Council (Special meeting)

Date: **Thursday 20 September 2012**

Title of Report: Barton Area Action Plan and Sites and Housing Plan Examinations

Main Modifications

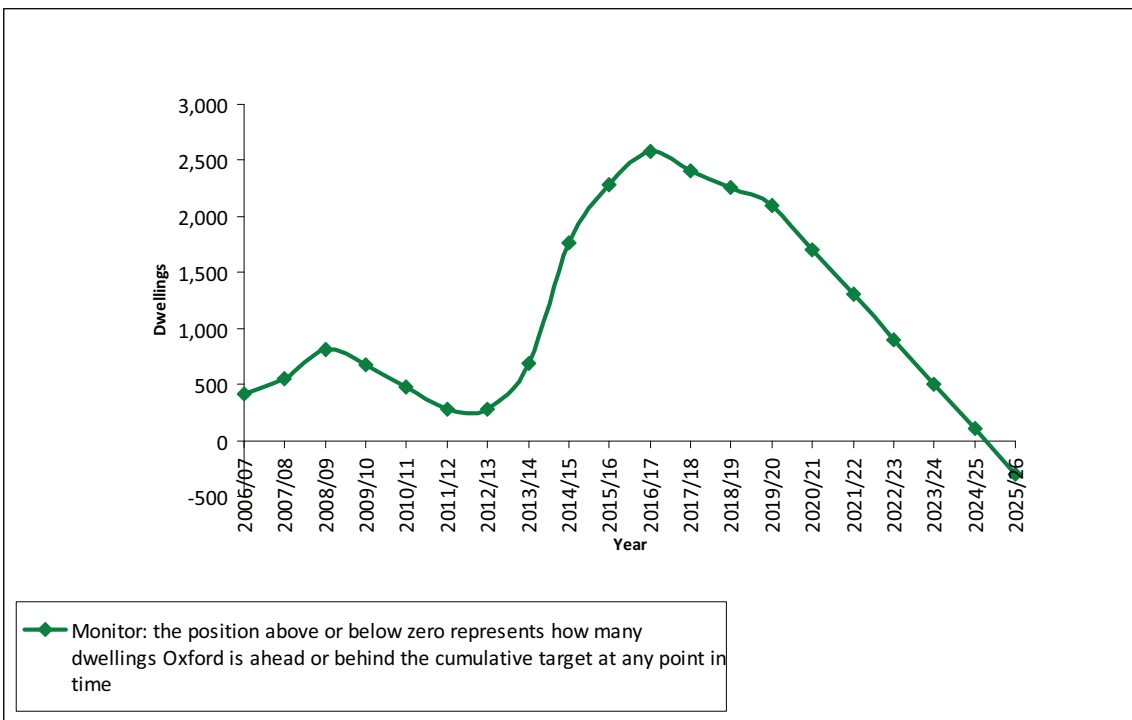
| MM2 | Map 1 | <p>Amend map:</p> <p>a. to show boundary of Strategic Site</p> <p>b. amend description of dark green line on Key to read 'Existing pedestrian <u>and/or</u> cycle ways'</p> <p>c. reduce size of arrows used to depict 'Access to countryside'</p> <p>d. correct depiction of link through centre of site (past substation) from a lime green dotted line, to a dark green line as it is an existing pedestrian and/or cycle way.</p> <p><i>See new Map 1 appended to this schedule</i></p> | <p>a. Inspector's request</p> <p>b. to remove ambiguity</p> <p>c. to remove ambiguity</p> <p>d. to correct factual error</p> | Yes | No | Previously referenced (in part) as PPC1 and EC6 |
